MHDNUNION
Access Design Assessment Report

17-19 Sydney Road
Manly NSW 2095

Project: 17-19 Sydney Road, Manly
Document Type: Access Design Assessment Report
Our Reference: P221_387-2 (ACCESS) KG

Figure 1 – Pedestrian Entries

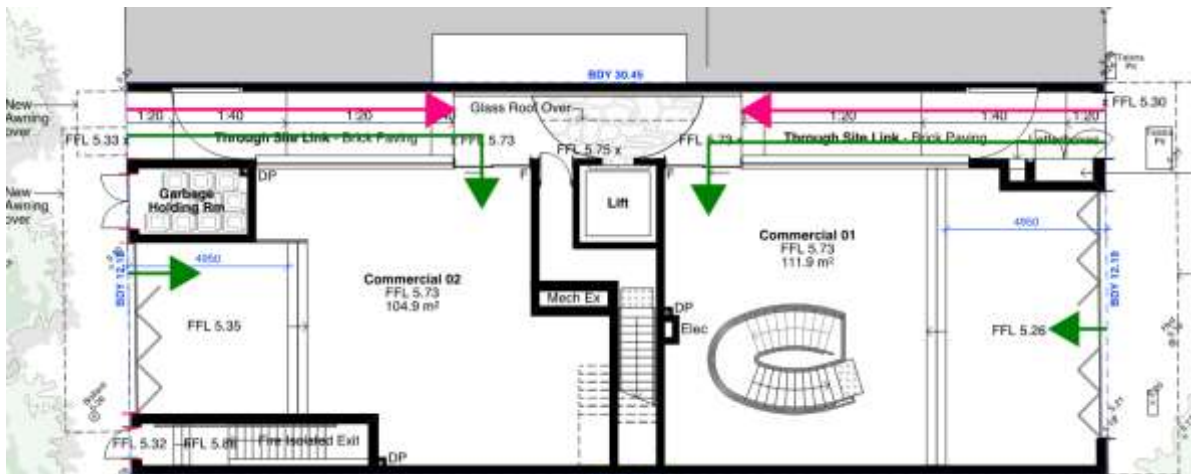
An accessway to residential part of building from the site boundary is proposed from Sydney Road and Market Place via 1:20 walkways and flat pathway, shown in **pink**. Commercial tenancies are accessed directly from public domain area and site link between Sydney Road and Market Place, shown in **green**.

DESCRIPTION	COMPLIANCE DEPARTURE	RESOLUTION
Bi-fold doors – principal pedestrian entry	Principal pedestrian points to retail tenancies 1 and 2 are proposed with bi-fold entry doors.	<p>Level of detail is suitable for DA stage.</p> <p>Bi-fold doors are not permitted on the accessible path of travel.</p> <p>Opt 1: Provide first leaf as hinged door with door circulation space and door opening, compliant with AS1428.1-2009.</p> <p>Opt 2: Alternatively seek a performance solution to justify current design.</p>
Level difference – principal pedestrian entries	Drawings indicate a rise of approx. 50mm is proposed at the principal pedestrian entries to retail units.	<p>Level of detail is suitable for DA stage.</p> <p>Opt 1: Provide step free entry from within site boundary in compliance with AS1428.1-2009.</p> <p>Opt 2: Alternatively seek a performance solution to justify current design.</p>
Door circulation area – principal pedestrian entries	Principal pedestrian entry door circulation areas to retail units are proposed on public domain area.	<p>Level of detail is suitable for DA stage.</p> <p>Evidence (official survey) will be required that public domain area is on a grade minimum 1:40 for the whole door circulation area required.</p>

Gates – entry corridors	Gates with nil latch side clearance are proposed on the main walkway leading to lift lobby on ground floor level.	<p>Level of detail is suitable for DA stage.</p> <p>Opt 1: Provide latch side clearance to gates/doors on a grade not less</p>

DESCRIPTION	COMPLIANCE DEPARTURE	RESOLUTION
		<p>than 1:40. Minimum 1450mm length for front approach.</p> <p>Opt 2: Alternatively seek a performance solution to justify current design (automated door will be required).</p>
Walkways	Walkways are proposed with landings at the bottom of the walkway located on public domain area.	<p>Level of detail is suitable for DA stage.</p> <p>Evidence (official survey) will be required that public domain area is on a grade minimum 1:40 in all directions. 1500mm length required to allow for 90-degree turn.</p>
Detailed drawings	Entry walkway detailed drawings have not yet been provided for assessment.	<p>Level of detail is suitable for DA stage.</p> <p>As design progresses detailed drawings will be required.</p> <p>Ensure walkway design complies with Clause 10.2 of AS1428.1-2009.</p>
